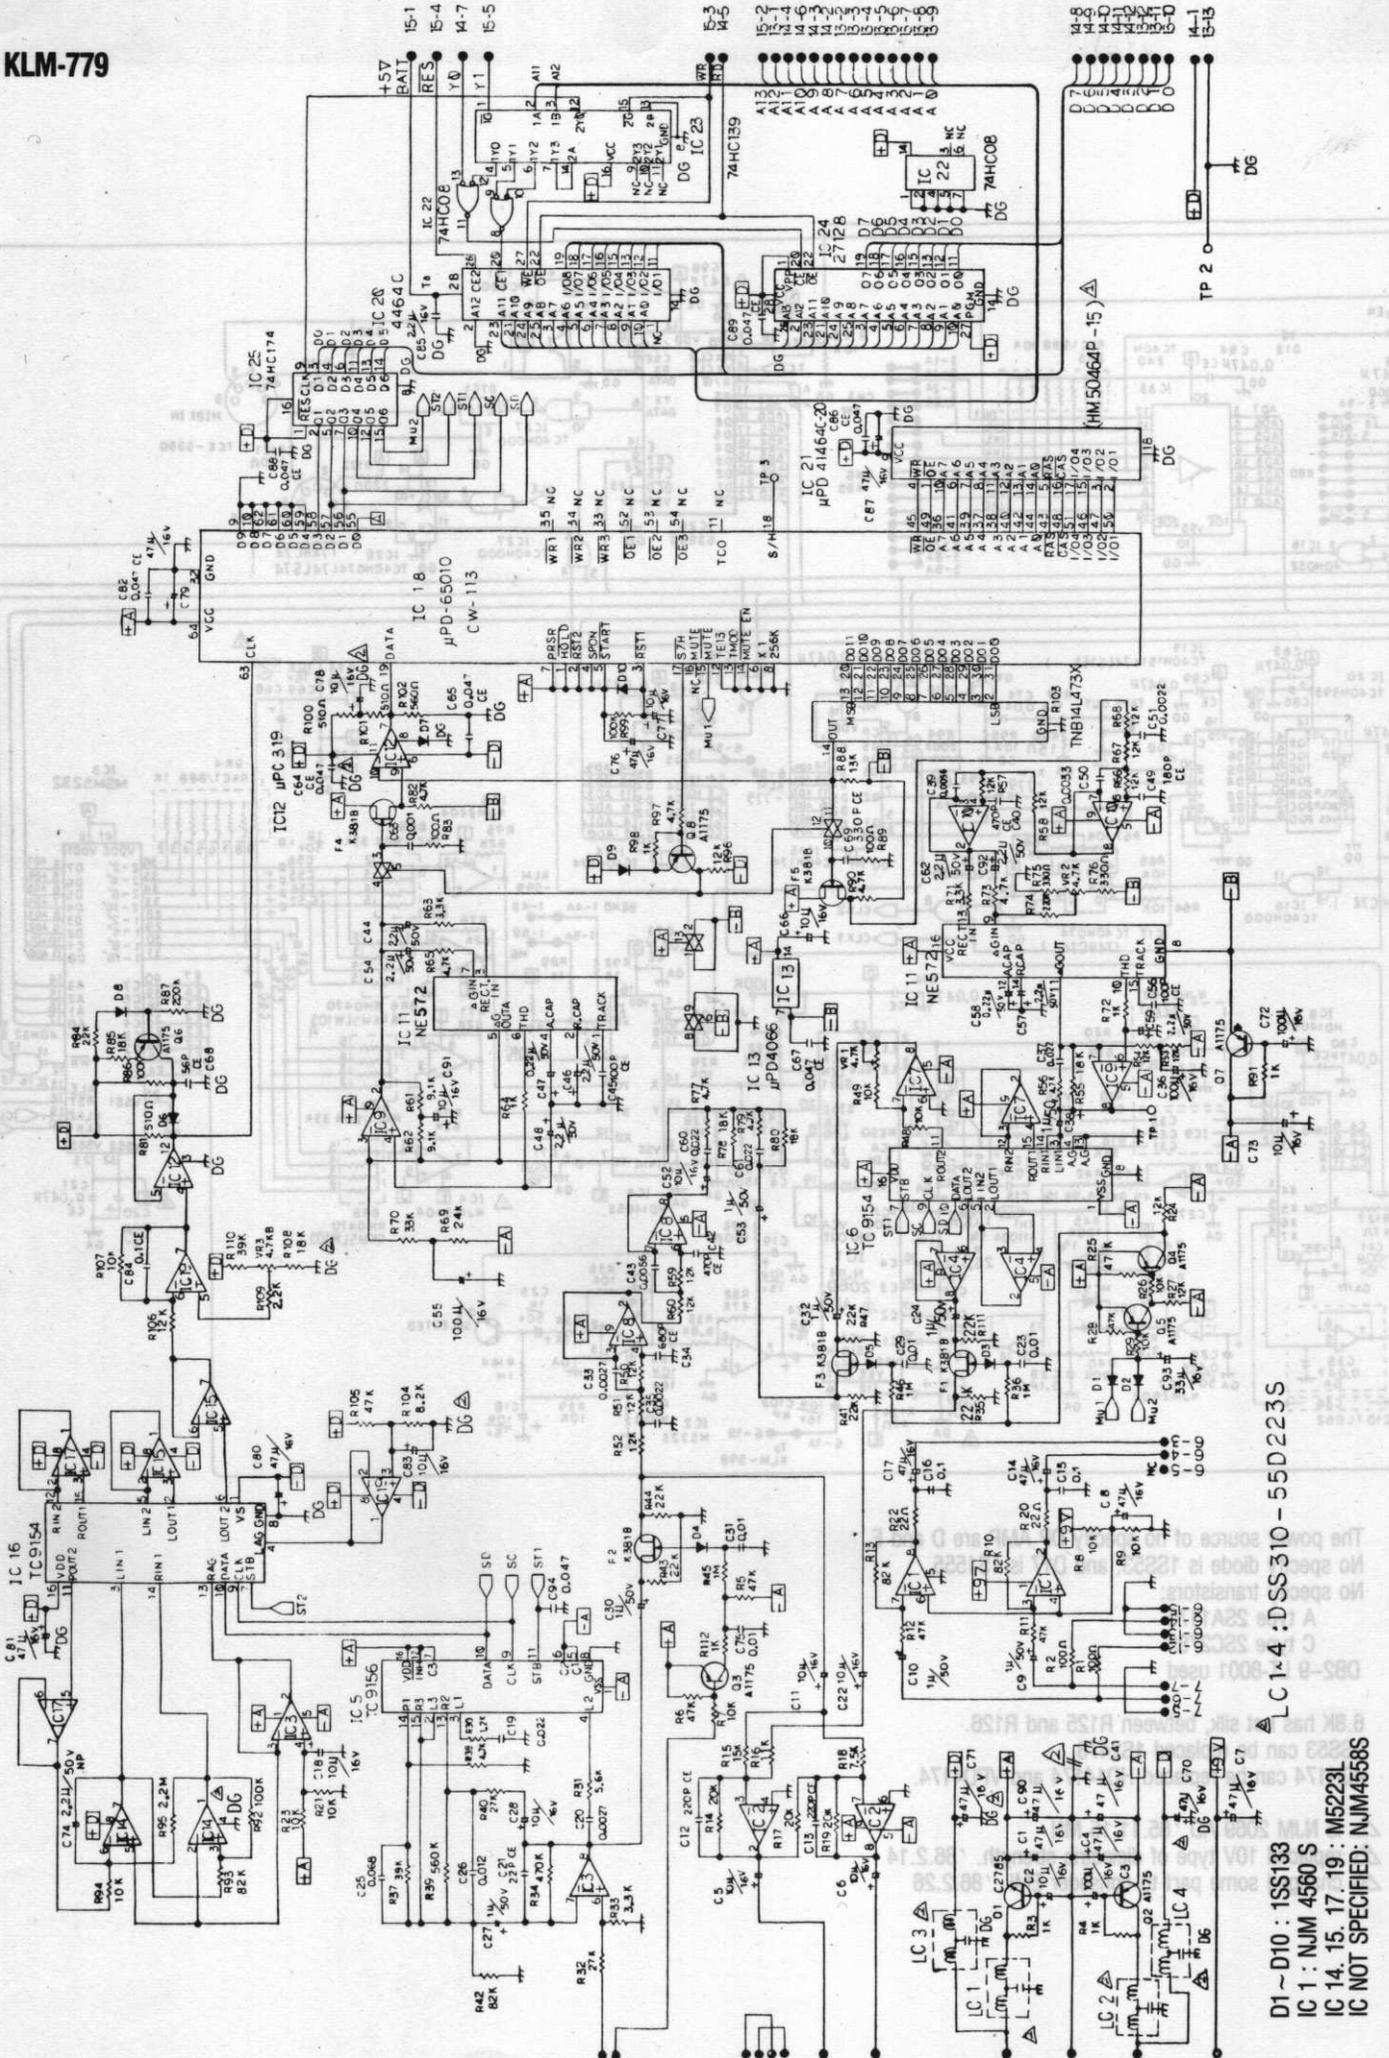
- ▲ Is NJM 2069 AD '85.11.15 MN
- ▲ replaced 10V type of dielectric strength. '86.2.14
- ▲ changed some part to consider EMI. '86.2.26
